## **Product Change Notice (PCN)**

PCN Number: PCN-0450882R-01

Product(s) Affected: PJ1-022-SMT-TR

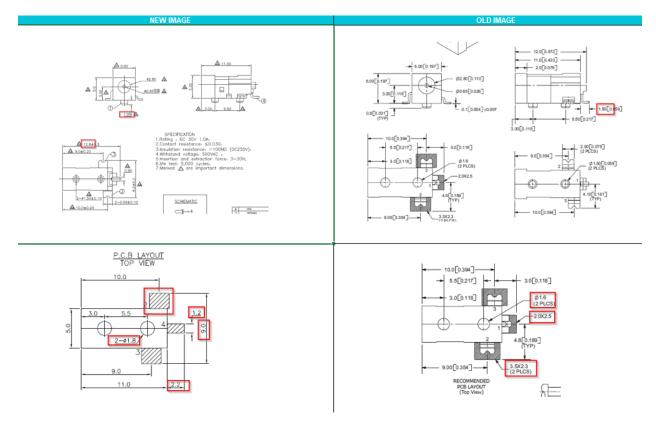
Description of Change: Minor Housing and footprint differences. Material Change on the

housing and terminals. See image Below

Housing and Terminal Material Changes:

Center Pin: Brass to Bronze

Terminal 2: Copper Alloy to Brass Plastic: PA6T or Equivalent to PA10T
